# SPACIO *Plus* & STALLION *Plus*

ENHANCEMENTS MADE TO THE EXISTING TILE  
BASED SYSTEMS TO GIVE A FRESHER AND BETTER  
LOOK AND FEEL TO OUR OFFERINGS

# INTRODUCING THE NEW SYSTEMS – SPACIO *Plus* & STALLION *Plus*

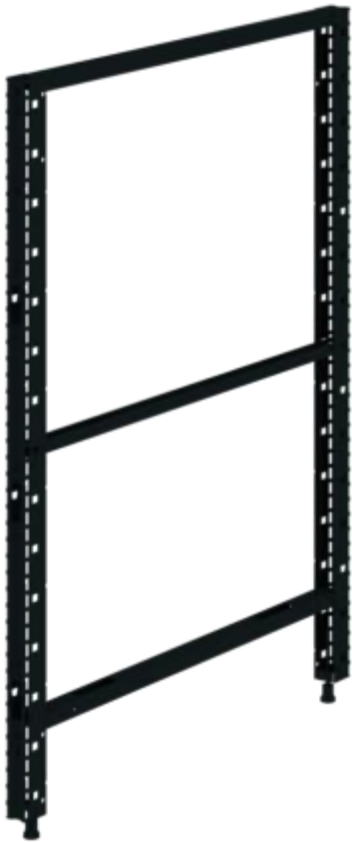
The Internal frame work is changed to give better rigidity , better fixing of tiles, enhanced and easier option for wire management, and supports larger height of tiles.

The overall height of the frame is reduced by 3" to match the overall panel height to 1200 mm.

- Normal frames – frame width of min. 1' to max 4'
- Bolted frames – options of 2 frames bolted together to form sizes from 3'6" to 5' frame offering
- Extended frames – new frames which can be offered without the 3way 90 deg trim on the aisle side.

The larger width of tiles (above 4' w) have been replaced with larger height of tiles.

Not only that, we can also offer tile heights now in the pitch of 3".

Tile divider panels have now been replaced by bolted frames.

4' 6" and 5' width of tiles which had issues of bowing has been discontinued. However, single raceways at the bottom level up to 5' can be offered.

More variety in the tiles heights are possible, by which, the horizontal gap seen in the panel can be reduced giving a cleaner look to the workstation.

Overall panel heights have been reduced to match tender specifications of the market.
